World Forum for Harmonization of Vehicle Regulations**Working Party on General Safety Provisions****125th session**

Geneva, 27–31 March 2023

Consolidated Resolution on the Construction of Vehicles**Proposal for Amendments to the Consolidated Resolution on
the Construction of Vehicles****Submitted by the experts from International Body and Trailer Building
Industry and European Association of Automotive Suppliers ***

Principle/Example of Driven Trailer Axles

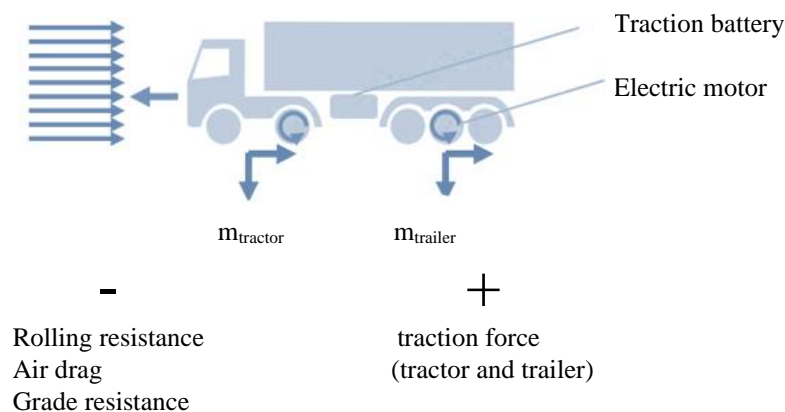
2. One of these features is a driven axle in a trailer/semi-trailer (e.g. with propulsion and/or recuperation system). Driven axles in trailers have the potential to support the motor vehicle (e.g. the tractor) during start-stop manoeuvres, during accelerating/braking and during transport of heavy loads under ambitious conditions (uphill/downhill) or may convert the kinetic energy of an axle to supply electric systems (e.g. cooling units for reefer). This leads to lower fuel consumption of the motor vehicle respectively cooling units (ergo lower CO₂ emissions) and higher agility of the whole vehicle combination.

3. The type of drivetrain may currently be electrical or hydraulic. The drivetrain on the trailer/semi-trailer will be controlled to safely follow the towing vehicle. The propelling capacity of any trailer/semi-trailer in a vehicle combination shall be controlled within the vehicle combination in such a way that the longitudinal/lateral stability of the combination is not negatively influenced. The drivetrain of the trailer/semi-trailer can operate in the full speed range of the vehicle combination and is not limited to low-speed applications. But the pushing of the towing vehicle by the trailer/semi-trailer is not permitted at speeds higher than 15 km/h. The trailer shall always remain in the towed condition with tensile forces in the coupling (except for the starting aid and except pushing forces that result from the normal dynamic conditions of the motor vehicle and trailer while driving/braking as it is usual today). Heavy trailers (categories O₃ and O₄) are predestined to be propelled by an electric or hydraulic engine to reduce the overall CO₂ emission of the tractor/lorry. But also propelled light trailers (category O₂) have a huge effect on vehicle dynamics. The use of a trailer (e.g. caravan) is mostly not foreseen in combination with battery electric cars or results in a huge reduction of the range due to the limited battery capacity of a car. This may lead to low acceptance of battery electric cars in a growing market of caravan users. But especially an electric propulsion in a trailer of category O₂ (e.g. caravan) would allow the use of this trailer in a combination with a battery electric vehicle. The e-trailer would be able to guarantee the normal range of the battery electric car in combination with the trailer without any further emissions.
